ERRATA

TO THE MSP50C6xx USER'S GUIDE

(TEXAS INSTRUMENTS LITERATURE NO. SPSU014, JANUARY 2000)

This document contains corrections and additions to information in the MSP50C6xx User's Guide (TI Literature Number SPSU014, January 2000).

FIGURE 1. Revised MSP50C604 Block Diagram

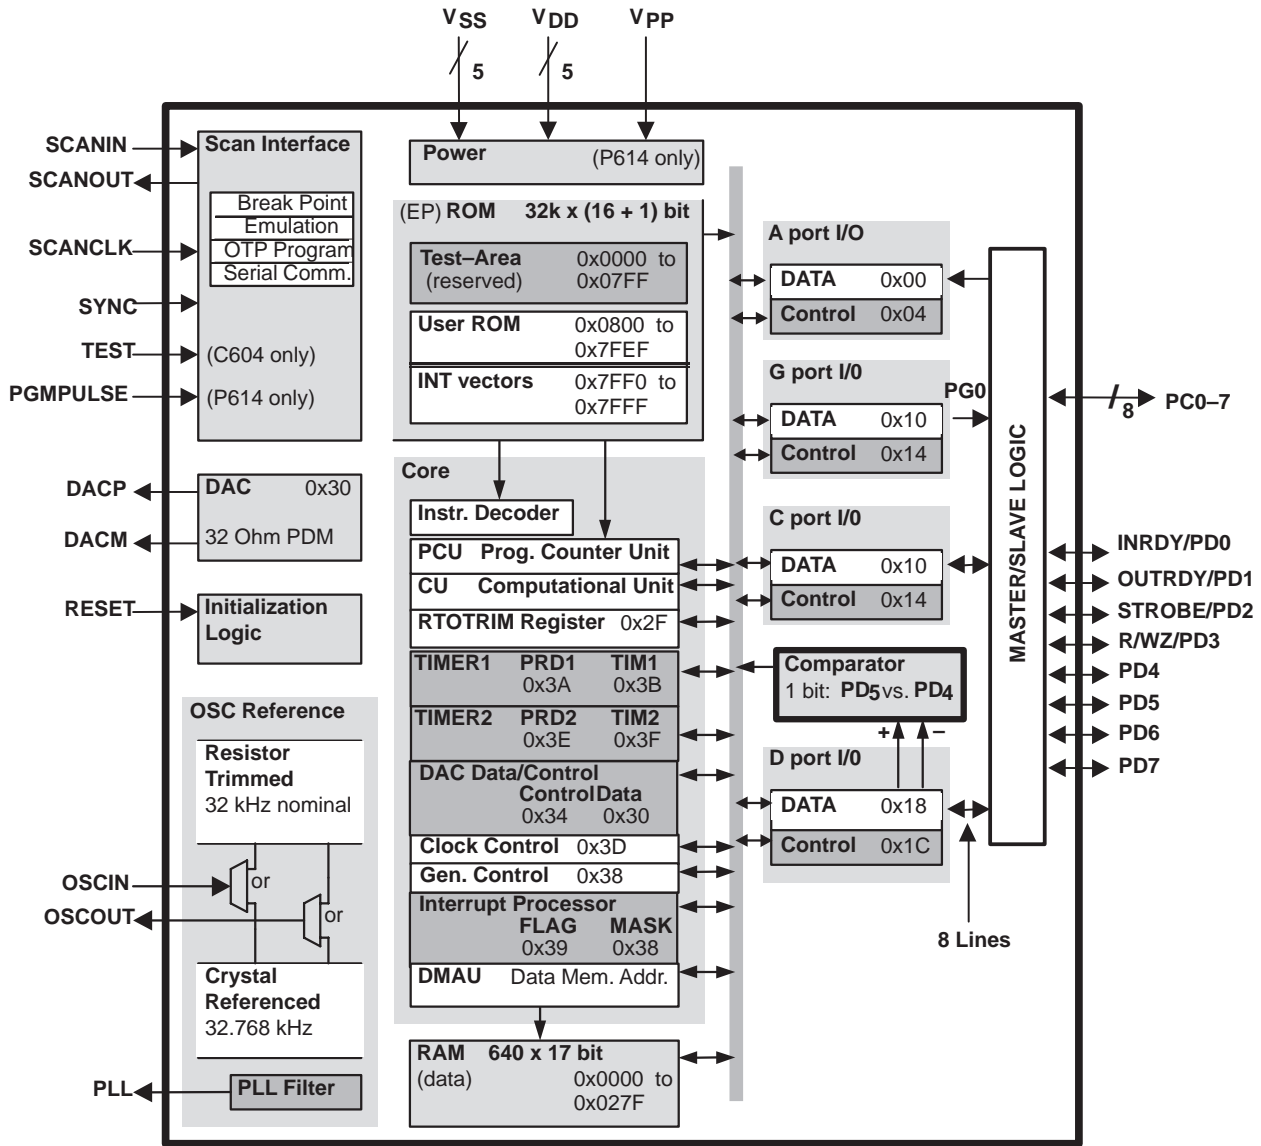
Errors	Page(s)	Table(s) or Figure(s)	Correction
INITZ	A–7	Table A–1	RESET
X1	1–11	Table 1–2	OSCIN
	1–12	Figure 1–4	
	7–3	Table 7–1	
	A–7	Table A–1	
	B–8	Table B–1	
	C–6	Table 1	
X2	1–11	Table 1–2	OSCOUT
	1–12	Figure 1–4	
	7–3	Table 7–1	
	A–7	Table A–1	
	C–6	Table 1	
X2 (Pin#13)	B–8	Table B–1	PLL
PLL (Pin#15)	B–8	Table B–1	OSCOUT
NC (Pin#31)	B–8	Table B–1	VCC
GND1 (Pin#48)	B–8	Table B–1	GND2
SCAN_OUT	A–7	Table A–1	SCANOUT
	B–8	Table B–1	
SCAN_IN	B–8	Table B–1	SCANIN
SCAN_CLK	B–8	Table B–1	SCANCLK
PG0	B–4	Figure B–1	Replace Figure B–1 with Figure 1 in this document
OSCIN, OSCOUT	1–10	Table 1–1	Exchange pad numbers (See Table 1 in this document)
